Access Compliance Report

Public Rights-of-Way

Intersection ID: 50103	Main Street: SUNFLOWER_VALLEY_DR	Cross Street: DOVE_MEADOW_DR	Location: W
ADA ID: 209D57617A78	Ramp Type: PerpDiag	Initial Pass/Fail: Pass	Overall Compliance: No
Severity Score: 5.25			
Codes/Mitigation Info/Possible Solution		Field Measurements/Component Compliance

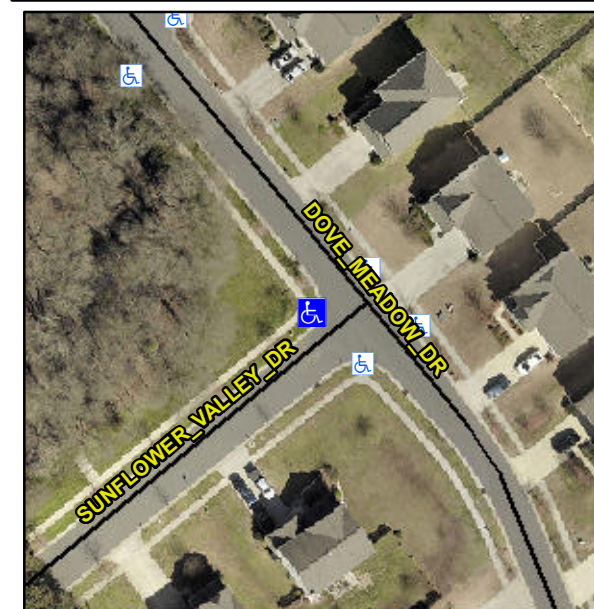
R304.5.3, R304.2.1, R304.2.2-Perp, R304.3.2-Para, R305.2, R304.5.4

Remove & Replace Curb Ramp With Two New Directional Ramps or Equivalent. Remove & Replace Gutter.
